MONTGOMERY COUNTY HISTORIC PRESERVATION COMMISSION
STAFF REPORT

Address:	5804 Connecticut Avenue, Chevy Chase	Meeting Date:	3/24/2021
Resource:	Outstanding Resource Chevy Chase Village Historic District	Report Date:	3/17/2021
Applicant:	Barbara Winnik (Phillip Long, Architect)	Public Notice:	3/10/2020
Review:	HAWP	Tax Credit:	NA
Permit Number:	943562	Staff:	Michael Kyne
PROPOSAL: Alterations, hardscape , and rear alterations

WINNIK RESIDENCE

5804 CONNECTICUT AVENUE, CHEVY CHASE, MD 20815

Fig. 2: 1927 Sanborn Fire Insurance Map, with subject property indicated by the blue star.

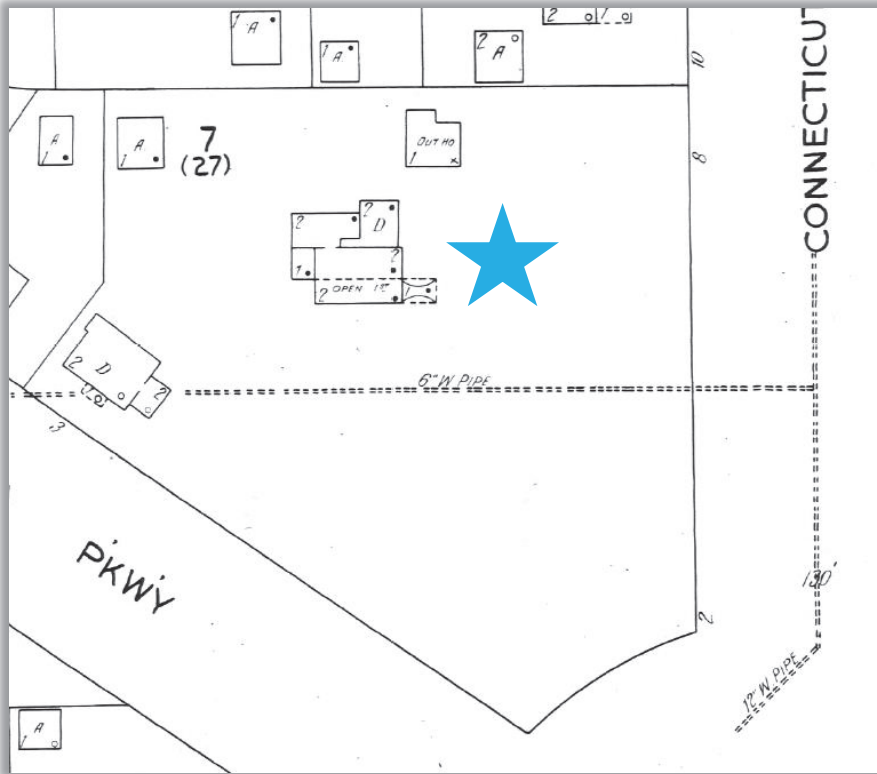
Although the 1927 Sanborn Fire Insurance Map (see Fig. 2 below) indicates that the portion of the building to be affected is original and/or historic, the proposed alterations are on a secondary elevation, and the proposed replacement windows are compatible with the style and materials of the historic house. Additionally, the proposed alterations will not be visible from the right-of-way, due to the property's location behind other houses on Connecticut Avenue. Accordingly, staff finds that the proposed window alterations will not compromise the integrity of character-defining features at the subject property.
